- **Bridge Abutment Justification**

- **Scour and Bed Protection Design**

- **Bank Protection Alternatives**

- **Weir Sensitivity Assessment**

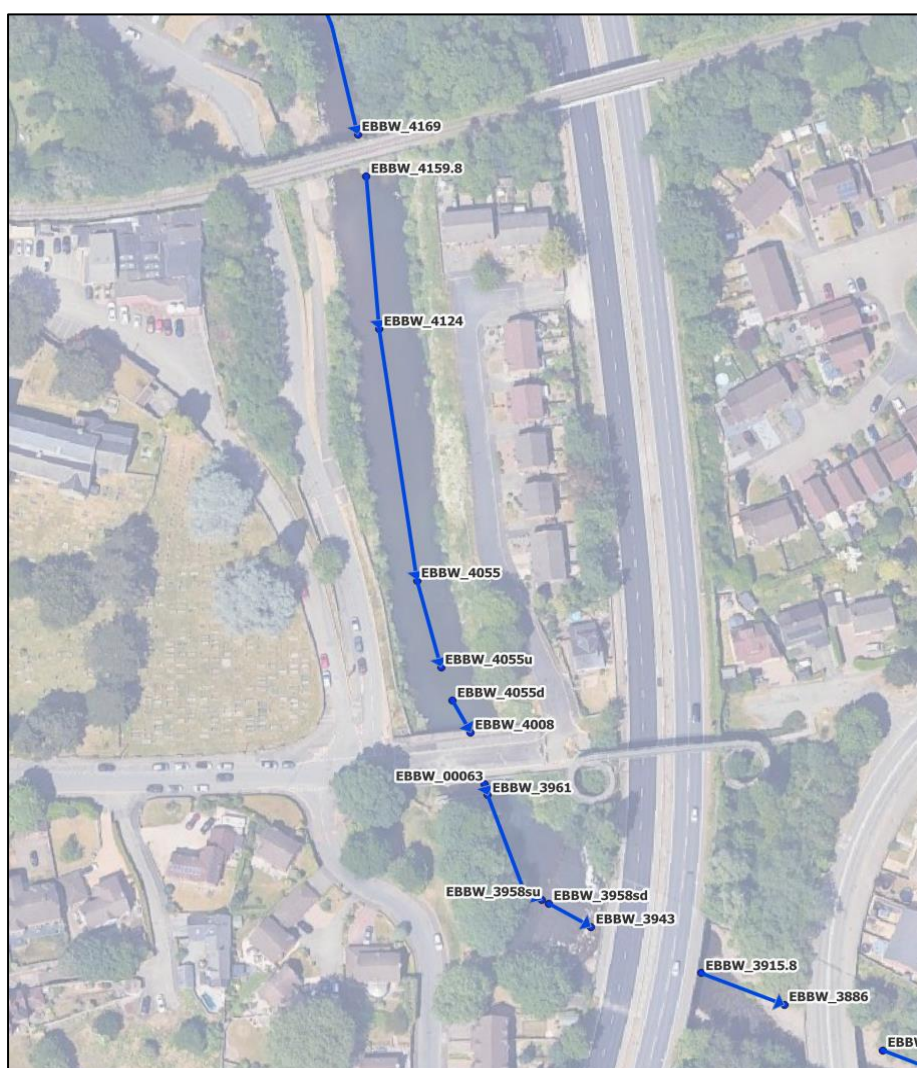
We request that a review of alternative bank protection methods be considered to reflect the geomorphology recommendation that green engineering solutions should be considered, to include:

- assessment of greener options such as vegetated rock rolls or bioengineering;
 - justification for the use of blockstone in the watercourse;
 - evidence that the selected method will not exacerbate bed scour or energy reflection.

- The bridge is required to have a design life of 120 years. The stability of the bridge is dependant on the performance of the scour protection as the bridge foundations have been designed assuming full embedment (i.e. no scour).

- Greener options were considered and investigated, however a product with a suitable design life, resistance to the expected velocities and that would be in keeping with the existing materials on site could not be identified. In addition, the difficulty, H&S risks and costs associated with replacing the scour protection once in-situ, meant that blockstones and rip rap were selected as the preferred scour protection options as these would require minimal maintenance during the design life. The blockstone protection also matches that which is currently in place, providing opportunity for material reuse and also blending the proposed design into the existing aesthetics of the area.

- Historic photos of the site (circa 2000/2001) show large rocky material being present around the old bridge, which suggests that this was present along the channel before the housing development at Viaduct Way was built. Therefore introduction of blockstone would be in keeping with this.

- In addition, due to the constraints of the site, such as: presence of mains utilities on the right bank and ensuring minimal changes to flooding up and down stream, the bank protection needed to have as small a footprint as possible to ensure that the cross sectional area of the opening under the bridge was as close to that of the original bridge as possible. The blockstone chosen ensured that these constraints could be met.

- The sediment transport process in a 50%AEP velocity, suggests that some size of material, if entrained by the flow from upstream, could deposit on the bed, rather than erode. This is then evened out by the effects of the calculated flood scour (ie a stop-start 'conveyor belt' of sediment transport). It is assumed that this episodic nature of sediment transport is what happens currently. We have provided protection for the length of the river bed where an increase in velocity at high flows is predicted due to the flow constriction that currently happens at the existing bridge.
